BONITA SPRINGS, FLORIDA
COMMUNITY DEVELOPMENT DEPARTMENT
ZONING DIVISION
STAFF REPORT

TYPE OF CASE: REZONE – RESIDENTIAL PLANNED DEVELOPMENT (RPD)
CASE NAME: BONITA SPRINGS GOLF COURSE RPD REZONE
CASE NUMBER: PD21-78545-BOS
HEARING DATE: January 11, 2022
PLANNERS: Mike Fiigon II, Senior Planner

EXHIBIT IV.E
 MASTER CONCEPT PLAN
 (TYPICAL ROADWAY SECTION)

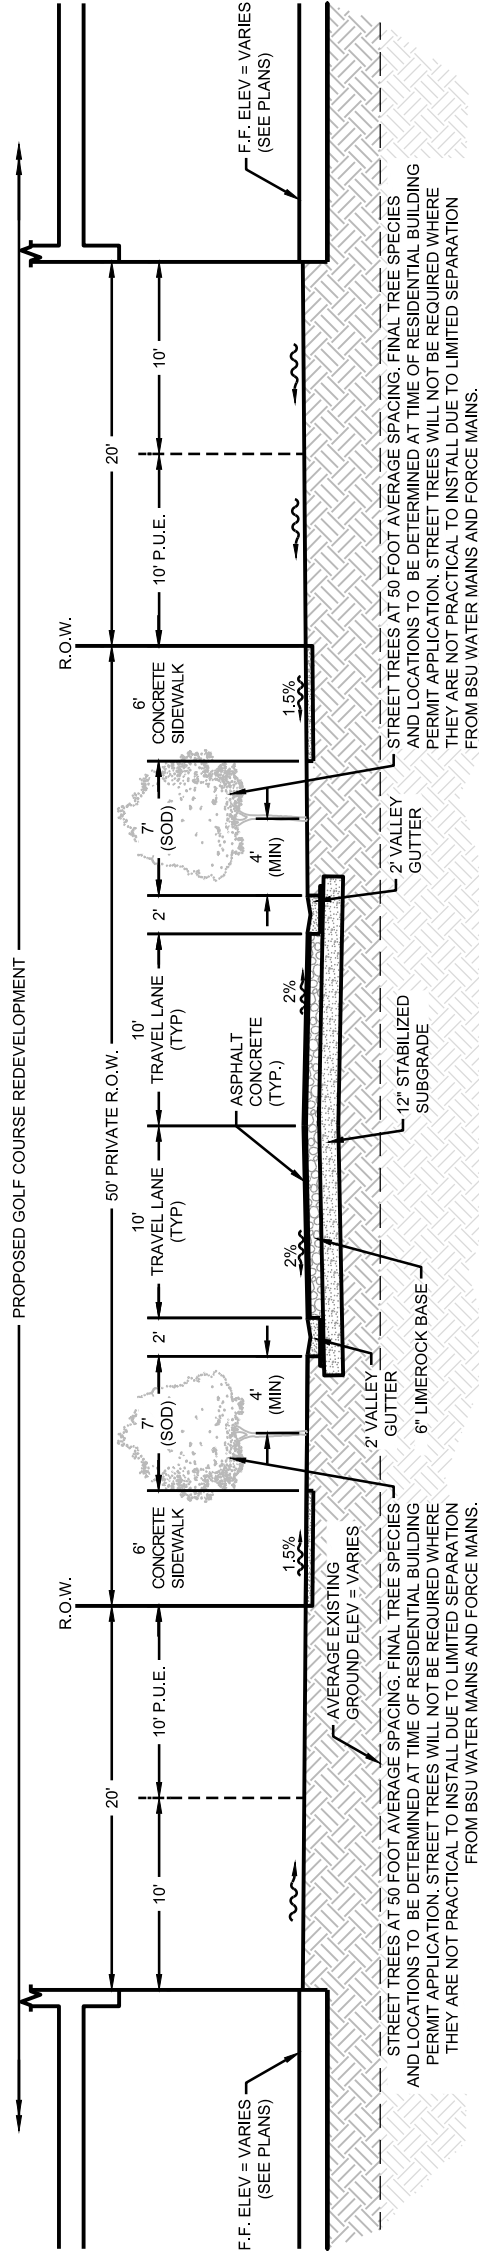
Staff Analysis: The Applicant is providing the required 6-foot-wide sidewalk on both sides and has agreed to mark the roadway with sharrows. As a result, the deviation request is not needed. Staff recommends the deviation be **WITHDRAWN**.

Staff Analysis: Based on the cross section provided on Page 3 of the MCP, the Applicant is providing street trees adjacent to the proposed sidewalks and vehicular travel lanes. The existing code provides for conflicts with utilities, stating that trees may not be placed where they will interfere with drainage, subsurface or overhead utilities, or in areas that would require frequent pruning due to overhead lines. Additionally, the LDC does not provide a spacing requirement for street trees. It is unclear as to the purpose of this deviation. It is Staff's opinion this deviation is not needed. Staff recommends the deviation be **WITHDRAWN**.

EXHIBIT IV.E
MASTER CONCEPT PLAN
(PATHWAYS)

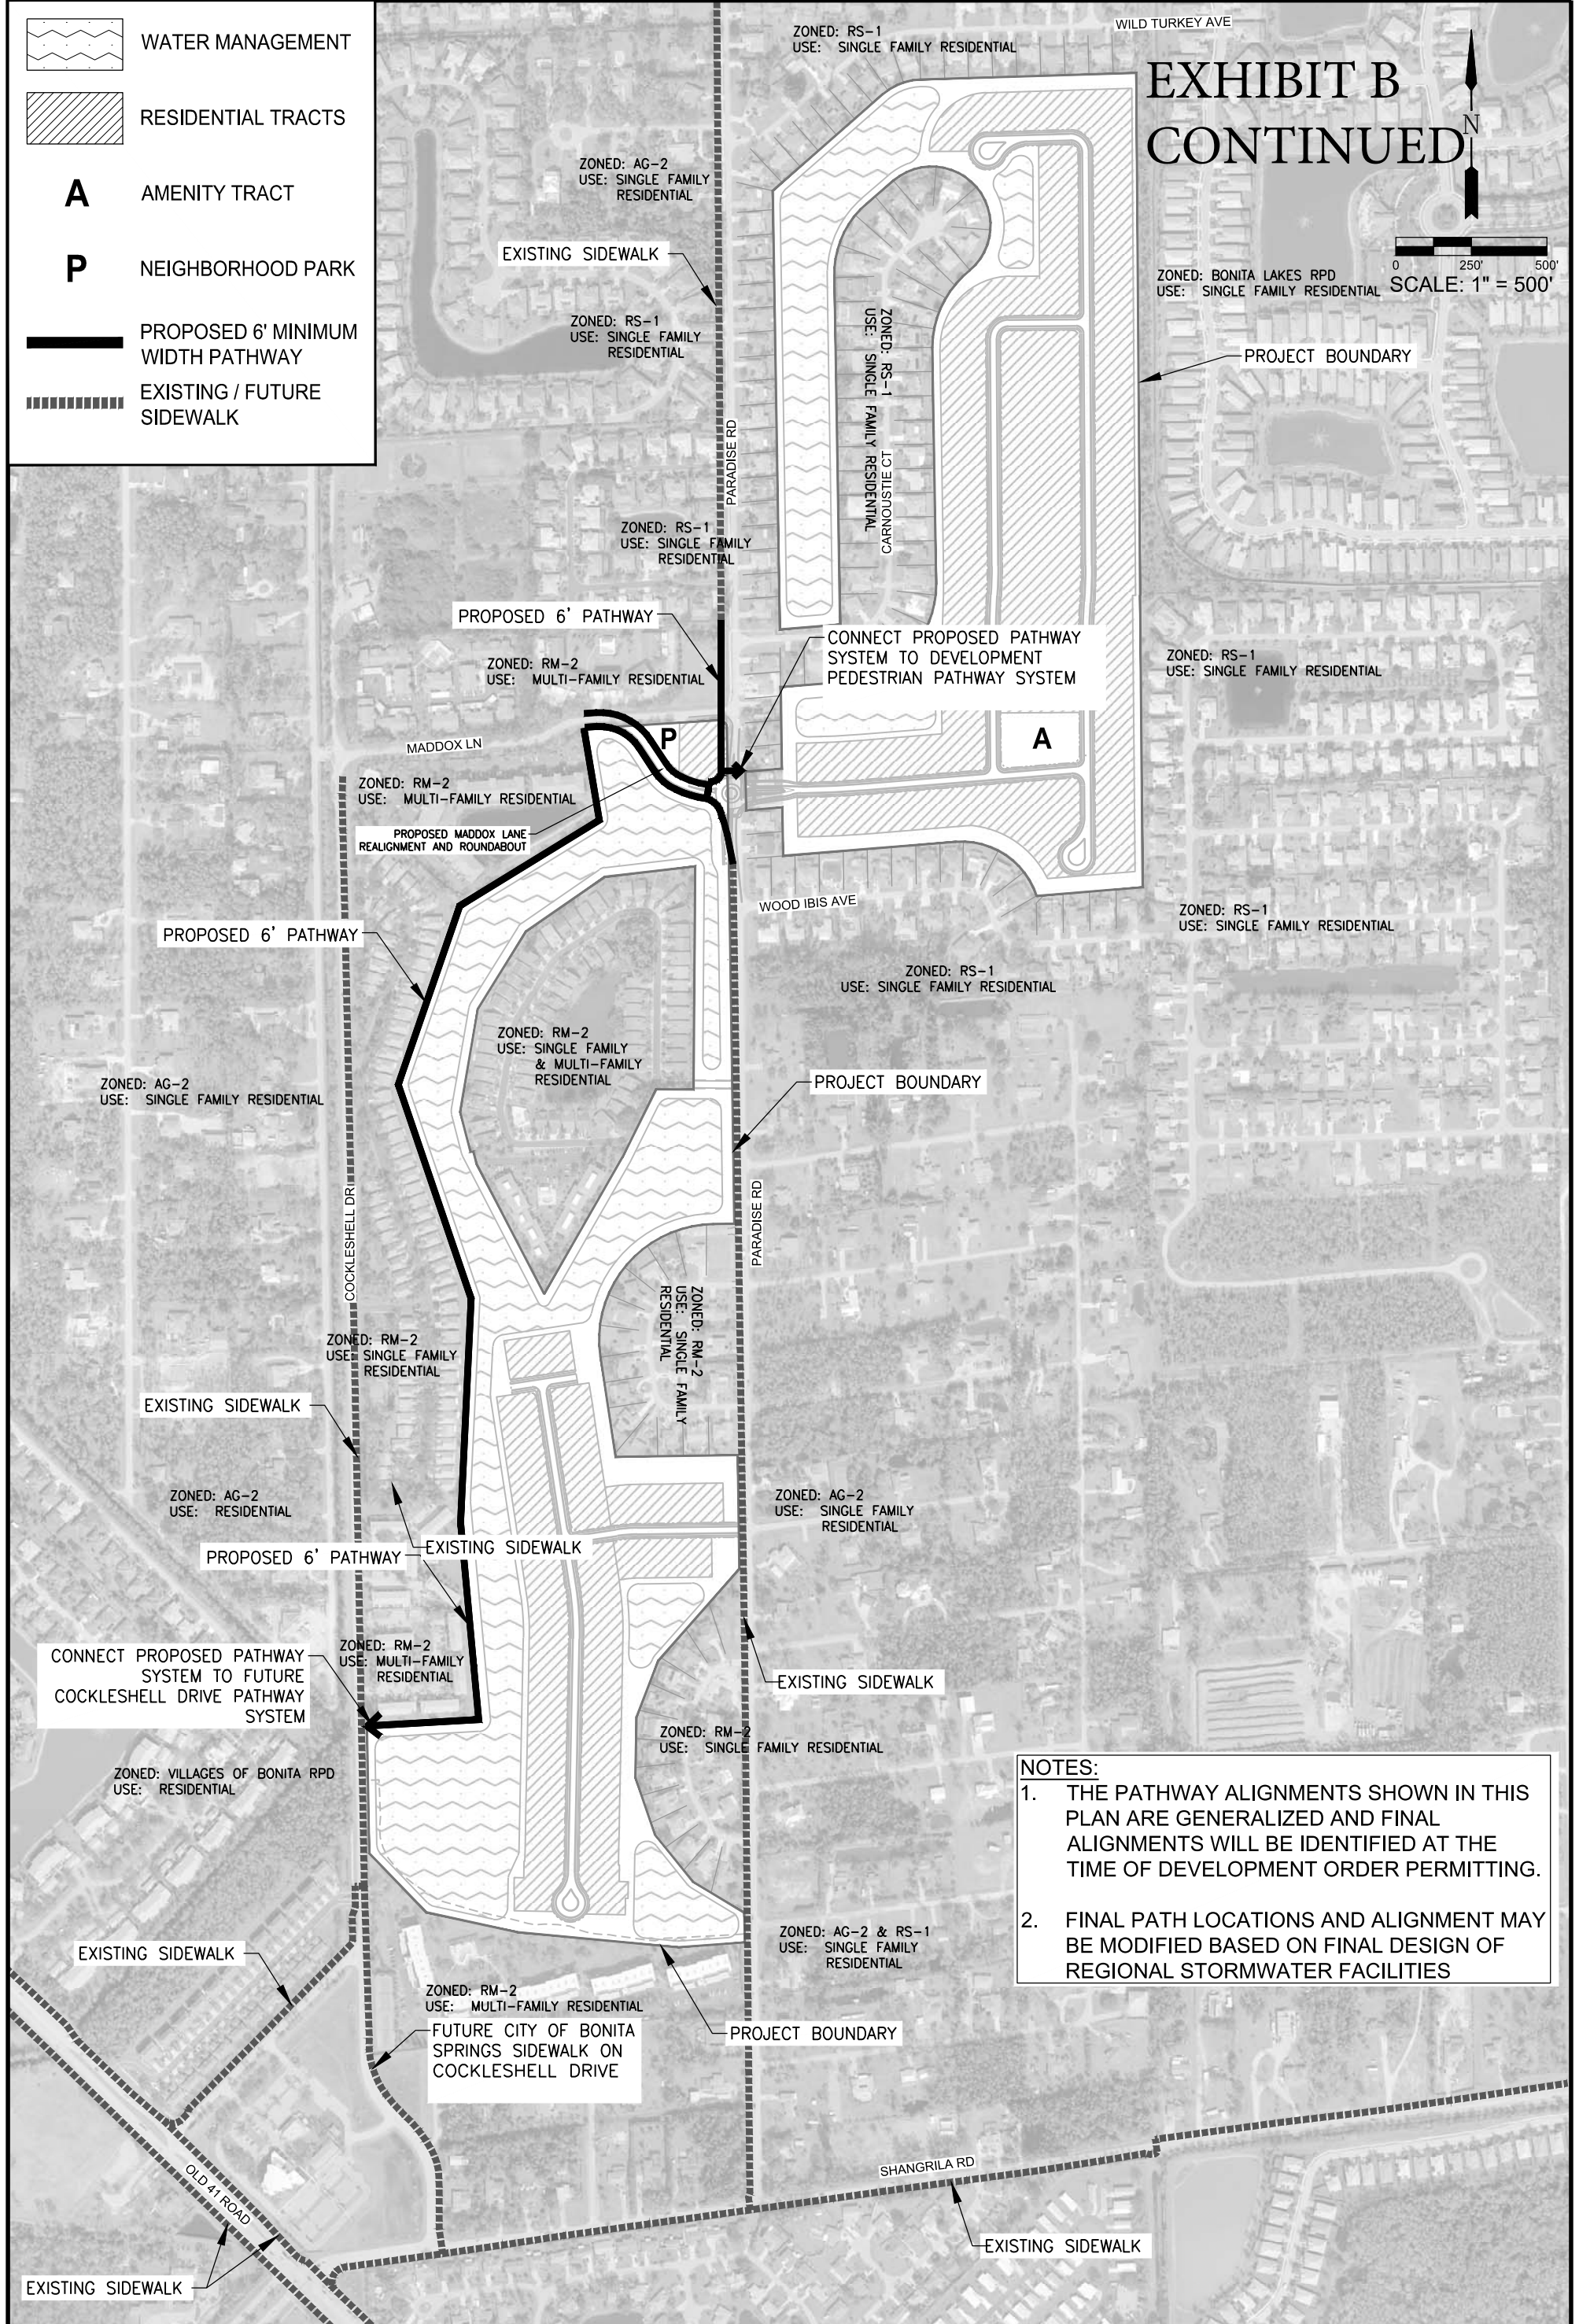
Staff Analysis: As part of the analysis that went into creating the Bicycle Pedestrian Master Plan, McMahon Associates, Inc. (the firm that developed the plan), conducted a needs assessment utilizing the area's existing bike-ped inventory in order to identify gaps in the multi-modal network. The purpose of the plan is to create a network of sidewalks, pathways, cycle lanes and multi-use trails for pedestrians and cyclists. Corridors that were studied were broken down into north-south corridors and east-west corridors. Paradise Road is a north-south corridor that was evaluated, as was Shangri La Road (east-west). As the Applicant indicates, a sidewalk currently exists along Paradise Road. However, the corridor has been identified as an area needing improvement to the network. The long-range plan calls for a 6-8-foot wide sidewalk, and a 10-12-foot wide multiuse pathway. At this time, only a 4-5-foot sidewalk exists. The Applicant is correct in that the Paradise Road right-of-way could be considered constrained and is further hindered by the existing open drainage swales, which would need to be enclosed and piped in order to create additional space to construct the required facilities. While the Applicant has primarily focused on exceeding the requirements for stormwater facilities, it has opted to provide an alternate pathways plan, which would take bike-ped traffic off the constrained Paradise Road right-of-way and route it through the proposed development via a 6-foot-wide pathway and connect to the existing sidewalk facilities on Cockleshell Drive towards the southwest end of the project. This pathway system is proposed to be available to the general public and can be used by residents and passers-by outside of the project's proposed development. With regards to the existing sidewalk on Paradise Road, due to the constrained right-of-way, the existing sidewalk is located approximately 2-3 feet away from the vehicular travel lanes. Staff is aware of public concern regarding the speed at which cars travel down the road in such close proximity to the existing pedestrian network. The current code requires a separation of a least 5-6 feet between the vehicular travel lanes and the sidewalk/pedestrian facilities. Because of the close proximity and speed, residents have expressed safety concerns about utilizing the existing sidewalk. To this end, the Applicant is proposing to construct a round-about as a traffic-calming device, aligning with the intersection of [a reconfigured] Maddox Lane and Paradise Road. Staff's opinion is that consideration should be given towards the Applicant's intent to address traffic-calming on Paradise Road, and the role it can play in providing a safer pedestrian experience within the existing network. At this time, Staff's opinion is that the alternate pathway plan meets the general intent of providing multimodal interconnectivity for the project area. Staff recommends **APPROVAL** of this deviation request, with the condition that the width of the alternate pathway be increased from a 6 foot minimum width, to a minimum of 8 feet in width.

5. The minimum width of the alternate pathway provided as part of Deviation 3 shall be no less than eight (8) feet.
6. The Applicant shall meet the notification standards of LDC 3-297(3) and must provide an emergency access plan to be reviewed by Staff at time of local development order submittal. The emergency plan must address life safety code requirements. Any modifications to the MCP that are necessary to address this issue may be reviewed administratively.

BONITA SPRINGS GOLF COURSE RPD
 EXHIBIT IV.E
 MASTER CONCEPT PLAN
 (FENCE / WALL LOCATION)

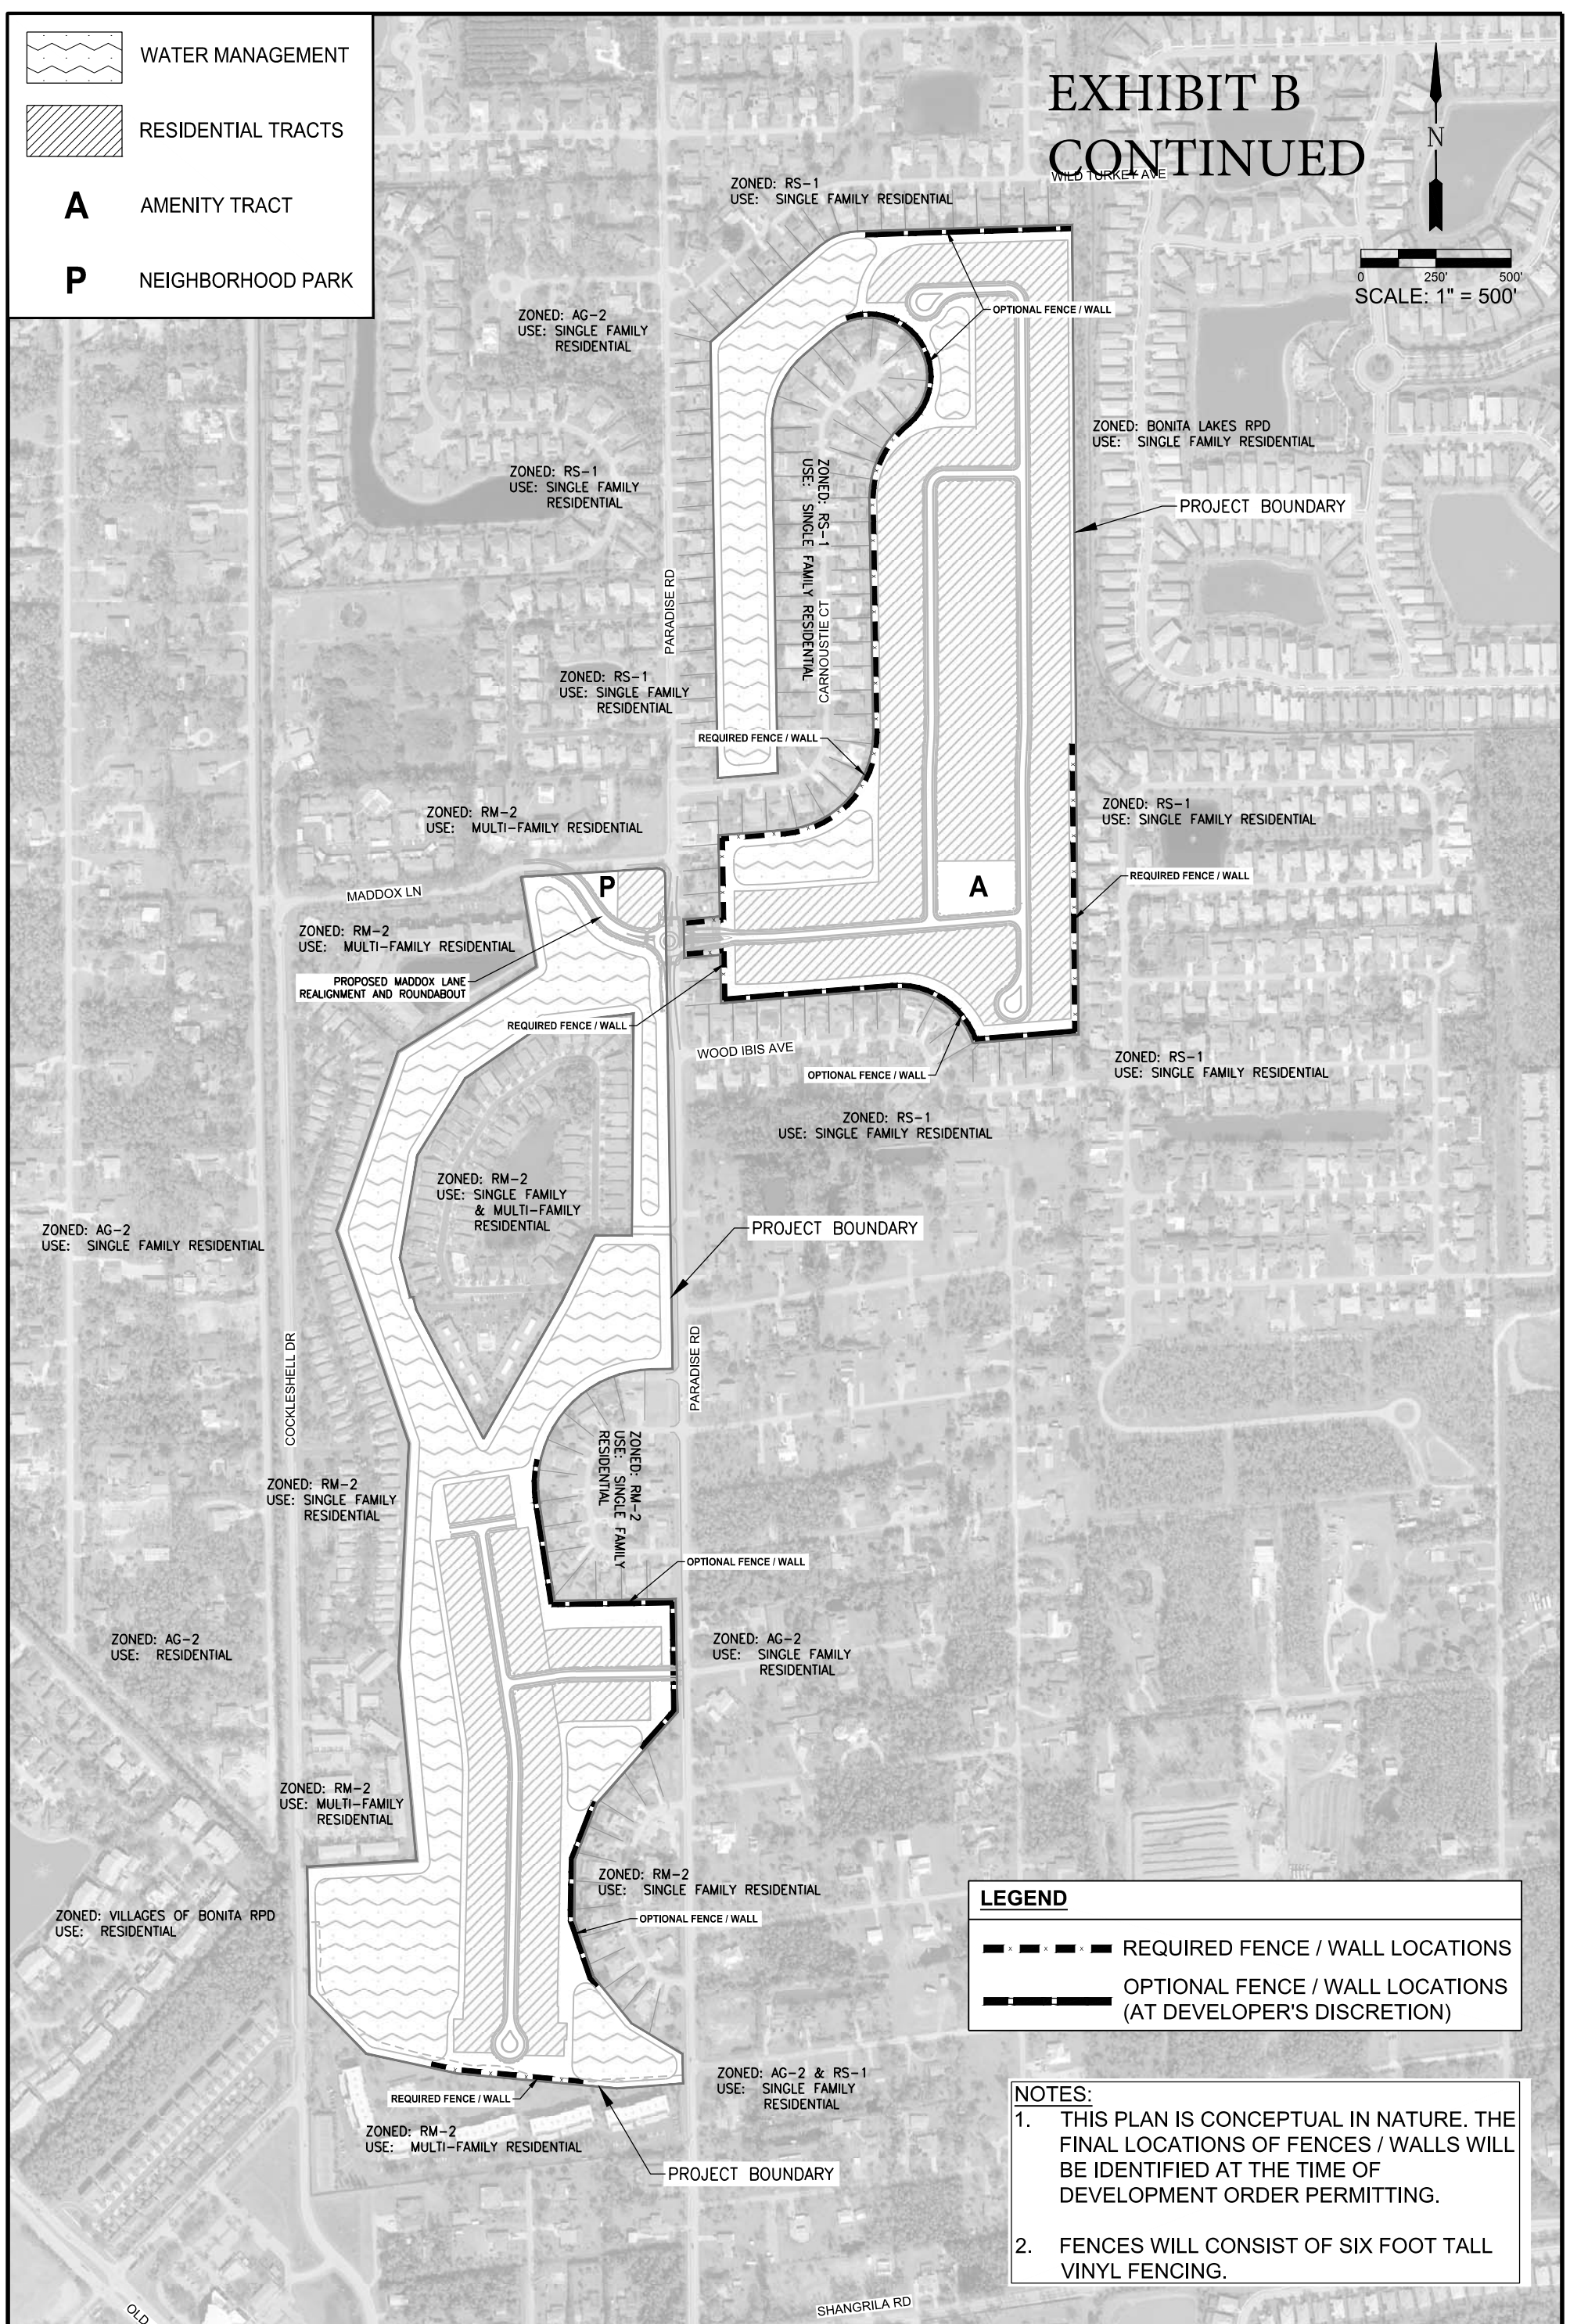
Regarding perimeter fences and walls, the intent of this regulation is similar to that of gates in that it is intended to foster a development that is not cut off or segregated from the surrounding communities. However, the existence of walls is more prevalent in surrounding neighborhoods on certain perimeter boundaries, or as decorative accents along a primary entryway. The code preference is to provide a landscape buffer in lieu of a physical wall or fence. However, the Applicant is accurate in its explanation that certain site constraints are prevalent due to the amount land that is intended to be utilized for stormwater attenuation, collection, and treatment. This results in certain development areas that are aligned more closely to a perimeter boundary to make room for additional stormwater areas and achieve the capacity necessary for this improvement and public benefit.

Staff recommends **DENIAL** of the proposed vehicular gated access. Staff recommends **APPROVAL** of the request to add walls in locations identified on the MCP, with the understanding

7. Pursuant to Deviation 1, all proposed perimeter fences/walls shall be treated as residential project walls, which, pursuant to LDC 4-1466 will require landscaping on the exterior side and a minimum planting width of seven and one half (7.5) feet. Where vegetation or walls/fences conflict with drainage facilities, alternative landscape plans shall be provided at time of local development order submittal.
